Access Compliance Report

Public Rights-of-Way

(Curb Ramps)

Intersection ID: 13561	Main Street: BAY_ST	Cross Street: LAMAR_AV	Location: E
ADA ID: 54185DAD3136	Ramp Type: PerpDiag	Initial Pass/Fail: Pass	Overall Compliance: No
		Severity Score: 10

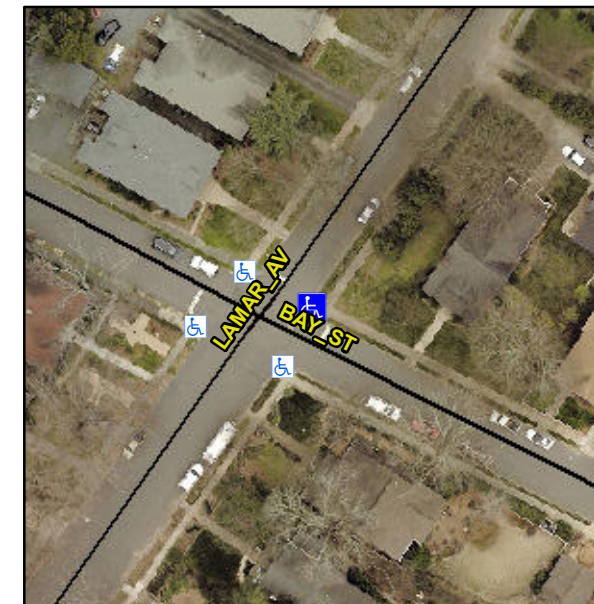
R304.2.1, R304.2.2-Perp, R304.3.2-Para, R304.5.3, R305.2

Remove & Replace Curb Ramp With Two New Directional Ramps or Equivalent.
